Access Compliance Report

Public Rights-of-Way

Intersection ID: 42733	Main Street: GRIER_SPRINGS_LN	Cross Street: COCHRAN_RIDGE_AV	Location: E
ADA ID: 2769880FDB27	Ramp Type: PerpDiag	Initial Pass/Fail: Fail	Overall Compliance: No
		Severity Score: 10

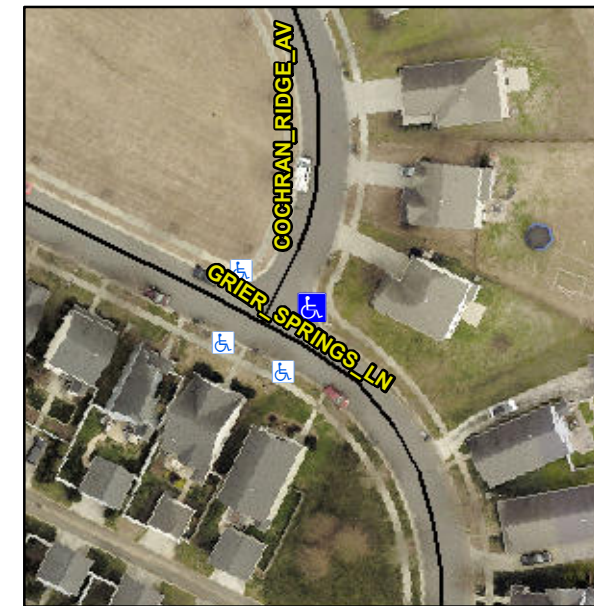
Not Found, R304.5.1, R304.5.3

Compliance	Description	Data	Compliance	Description	Data
N/A	Ramp Length (in)	65.0	Yes	Ramp Slope (%)	6.4
No	Ramp Width (in)	42.5	No	Ramp XSlope (%)	4.2
N/A	Flare Type LT	N/A	N/A	Flare Type RT	N/A
N/A	Flare Slope LT (%)	N/A	N/A	Flare Slope RT (%)	N/A
N/A	Flare Traversable LT?	N/A	N/A	Flare Traversable RT?	N/A
N/A	Landing Length (in)	N/A	N/A	DWS Provided?	N/A
N/A	Landing Width (in)	N/A	N/A	DWS Contrast?	N/A
N/A	Landing Slope (%)	N/A	N/A	DWS Length (in)	N/A
N/A	Landing X Slope (%)	N/A	N/A	DWS Full Width?	N/A
N/A	Landing Curb? (Y/N)	N/A	N/A	DWS Offset (in)	N/A
N/A	Shared Landing?	N/A			
N/A	Gutter Ponding?	N/A	N/A	Gutter Slope (%)	N/A
N/A	Gutter Lip Ht (in)	N/A	N/A	Gutter X Slope (%)	N/A
N/A	Painted X Walk1?	No	N/A	Painted X Walk2?	No
	X Walk 1 Direction	To N		X Walk 2 Direction	To S
N/A	X Walk 1 Width (in)	N/A	N/A	X Walk 2 Width (in)	N/A
	X Walk 1 Slope (%)	1.5		X Walk 2 Slope (%)	1.7
	X Walk 1 X Slope (%)	3.0		X Walk 2 X Slope (%)	1.2

Remove & Replace Curb Ramp With Two New Directional Ramps or Equivalent.
